STAFF REPORT
COMMUNITY DEVELOPMENT DEPARTMENT

HEARING DATE: 12/6/2022
 TO: Mayor & City Council
 FROM: Joe Dodson, Associate Planner
 208-884-5533
 SUBJECT: H-2022-0064
 Hadler Neighborhood
 LOCATION: Located at 7200 S. Locust Grove Road, approximately 1/2 mile south of the Locust Grove and Lake Hazel intersection on the east side of Locust Grove, in the N 1/2 of the SW 1/4 of Section 5, Township 2N, Range 1E.

MERIDIAN, ID PRELIMINARY PLAT LANDSCAPE PLAN

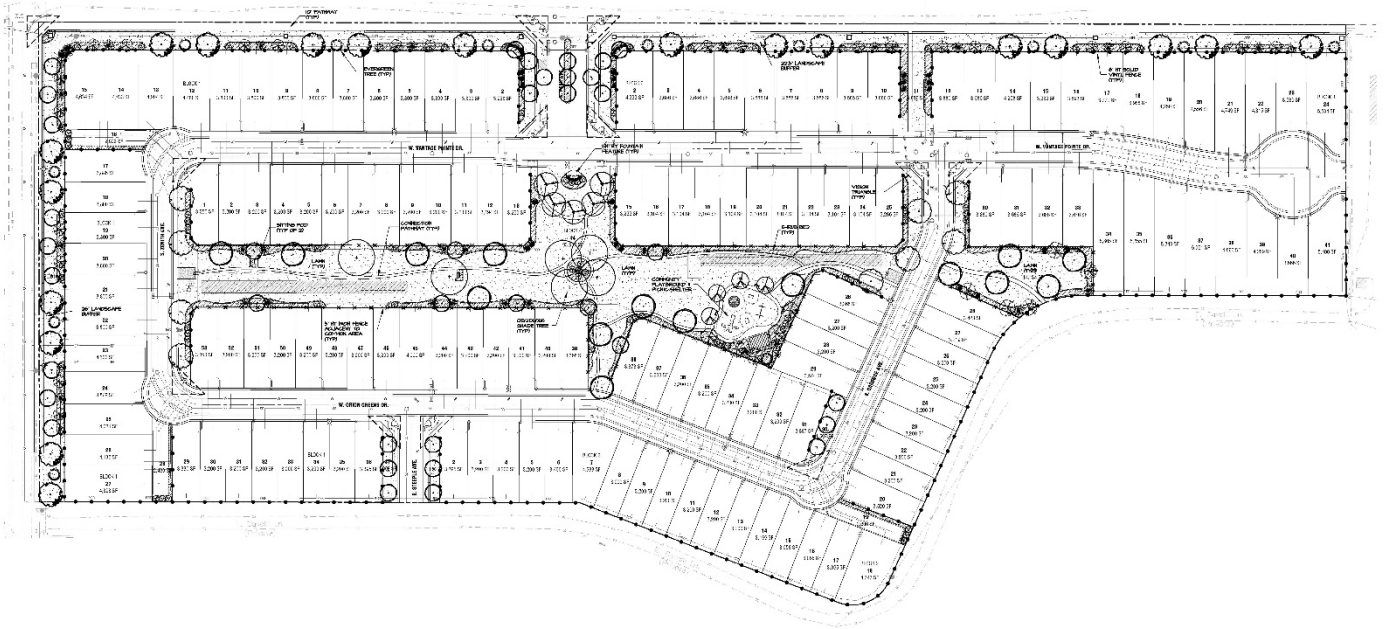
The pathway along Locust Grove appears to be attached to Locust Grove which does not comply with the UDC or Master Pathways Plan. So, the Applicant should revise the plat and landscape plan to depict this 10-foot pathway to be located within the required 25-foot buffer to Locust Grove and at least four (4) feet outside of the ultimate ROW to ensure the pathway remains detached.

The Applicant is showing a 25-foot wide common lot along Locust Grove that is a 22.5-foot wide common lot along Via Roberto consistent with code requirements. The landscape buffers are depicted with trees in excess of code and include landscape beds with shrubs and other vegetative ground cover, consistent with UDC 11-3B-7. Therefore, Staff finds the proposed street buffers comply with all UDC requirements. In addition, all open space areas are shown with trees, sod, and other landscaping in excess of minimum code requirements.

the smaller common open space area along the southeast boundary. However, Staff is not sure if the landscape buffers to the adjacent public streets meet the enhanced buffer requirements outlined in UDC 11-3G-3B.3 to count towards the open space. Previously, these areas automatically qualified towards the minimum open space but this is no longer the case with the latest open space code updates that desires for more than the minimum to be included within the required buffers in order to count towards the overall qualified open space for a project. The Applicant appears to comply with the first two points outlined in code but may not comply with the last two points: enhanced amenities with social interaction characteristics; and, enhanced context with the surroundings.

Staff recommends the Applicant provide evidence these buffers are enhanced beyond the pathway, trees, and grasses. For example, boulders, additional vegetation, decorative elements, decorative fence/walls, additional micro-pathways, etc. The burden of proof for the proposed common open space to qualify falls on the Applicant and not on Staff.

- ~~3. The landscape plan included in Section VII.C, dated July 29 November 2, 2022, shall be revised as follows prior to submitting for Final Plat approval:~~

- a. ~~Revise the landscape plan to match the revisions made to the street section of Vantage Pointe Drive on the latest preliminary plat.~~
- b. ~~Make the necessary revisions to the landscape plans to match the plat revisions noted above in VIII.A.2.~~

- c. ~~Depict the 10 foot pathway along S. Locust Grove to be located within the required 25-foot street buffer and located at least four (4) feet outside of the ultimate ROW to ensure the pathway remains detached, consistent with UDC 11-3B-7C.1a.~~

D. Open Space Exhibit:

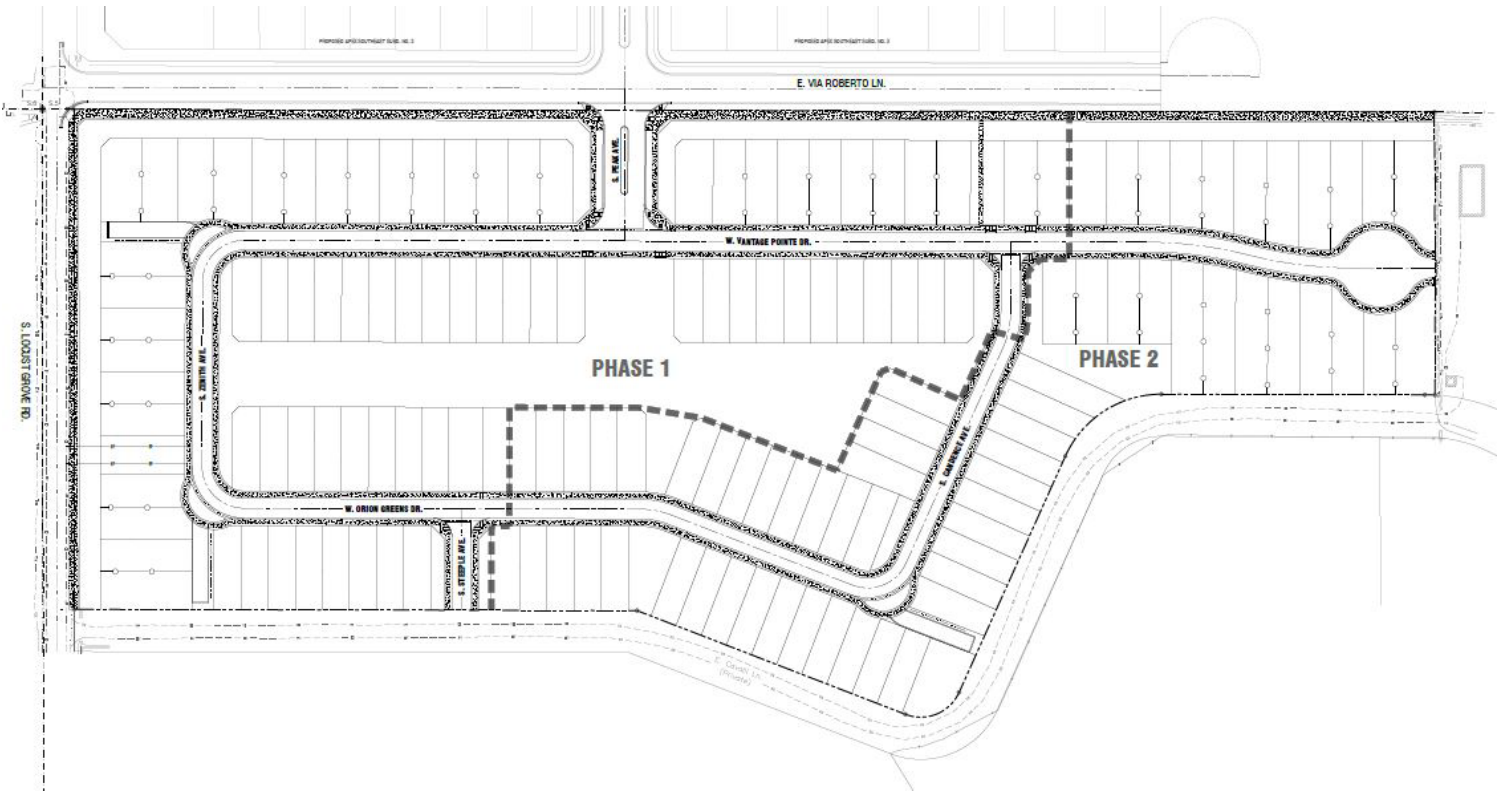
of 15% qualified open space. Per the calculations, the minimum amount of qualified open space required is 3 acres. According to the submitted plans, the Applicant is proposing 3.49 acres of qualified open space, exceeding the minimum amount required. The proposed 3.49 acres equates to approximately 17.45% qualified open space.

If these buffers do not count towards the minimum qualified open space, approximately 1 acre of land must be removed from the calculation leaving approximately 2.5 acres of qualified open space which does not comply with the minimum qualified open space requirement. Therefore, the Applicant should provide evidence that the proposed street buffers are qualified open space prior to the Commission hearing OR apply for Alternative Compliance to reduce the amount of qualified open space required due to the project's proximity to Discovery Park to the northeast.

4. ~~Prior to the Commission hearing, the Applicant shall provide evidence that the proposed street buffers are qualified open space OR apply for Alternative Compliance prior to the City Council hearing to request a reduction to the amount of qualified open space required.~~

SHARED DRIVEWAY EXHIBIT

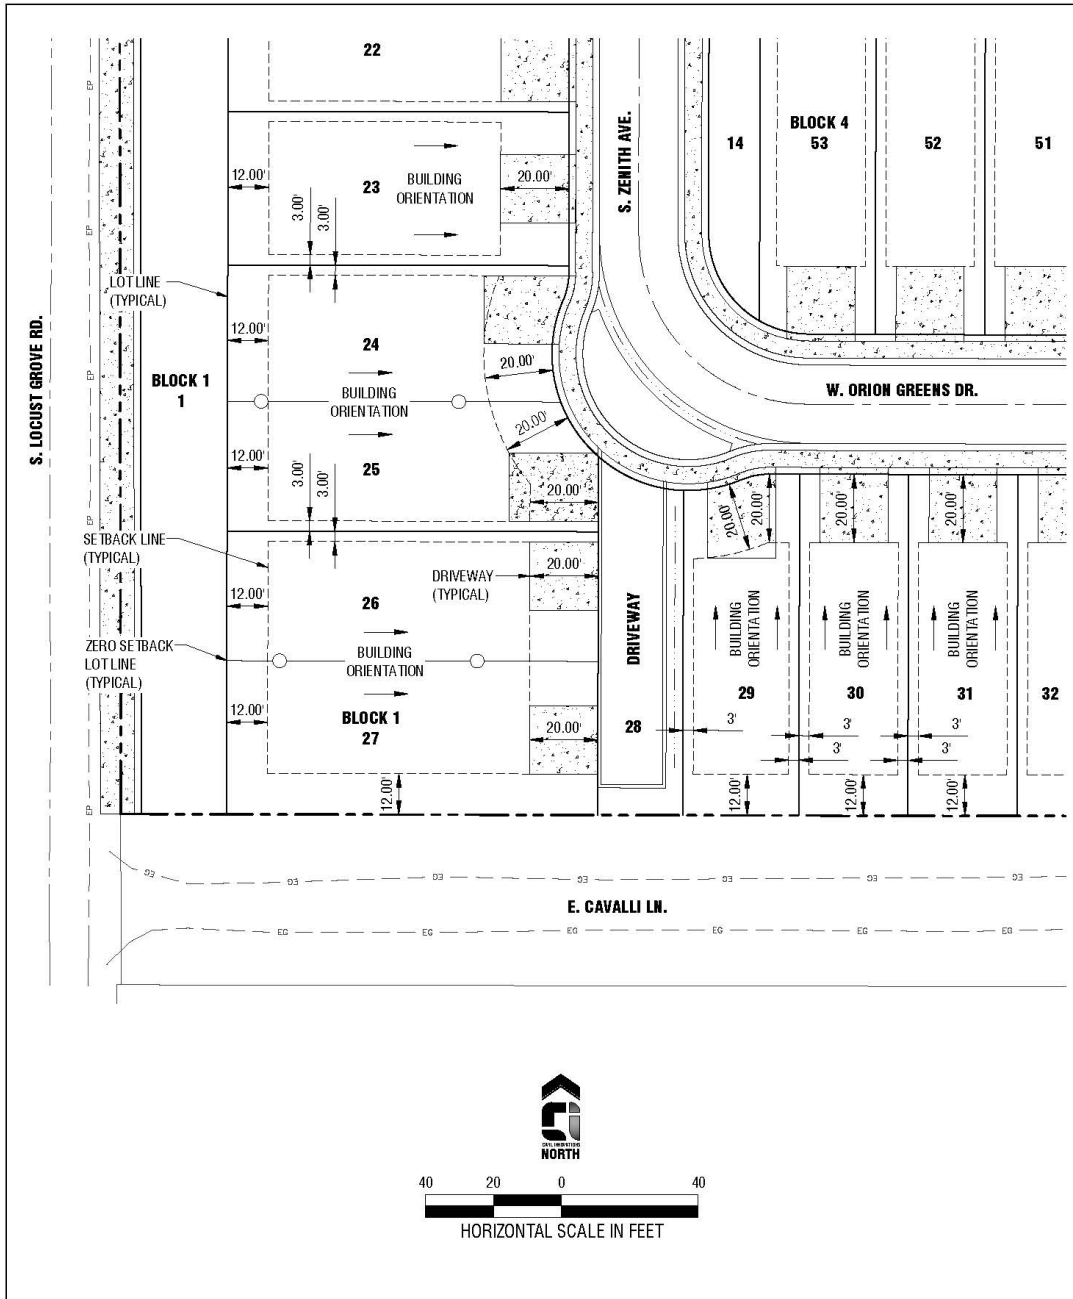
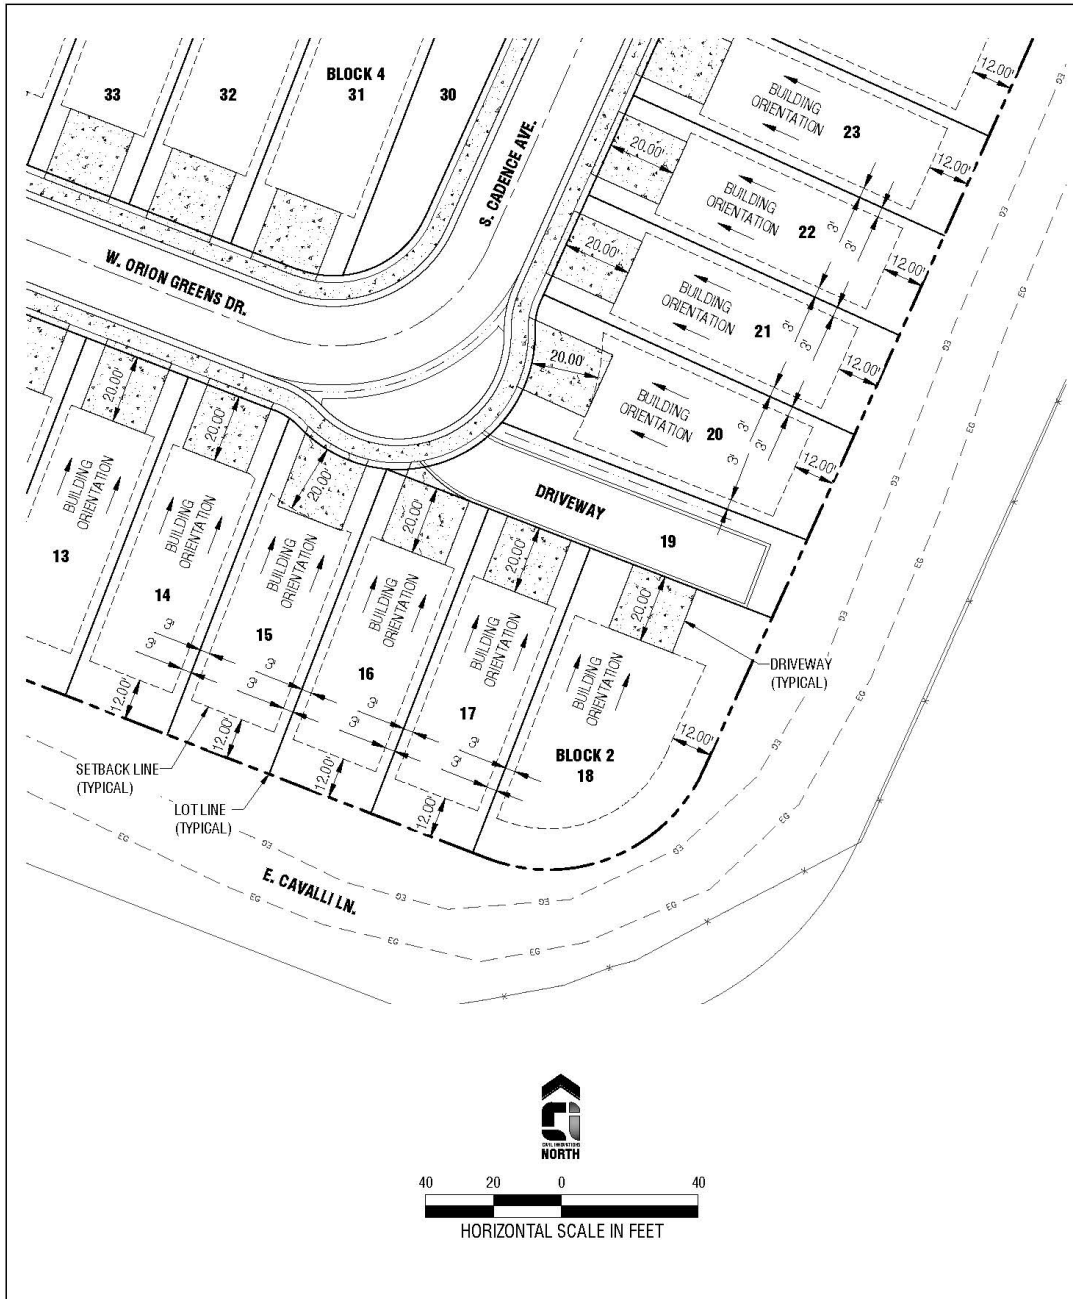
The three (3) proposed common drives depict 3 lots taking access from each of them and include at least 5 feet of landscaping adjacent to the abutting lot not taking access from the common drive. The proposed common drive design complies with UDC 11-6C-3D requirements.
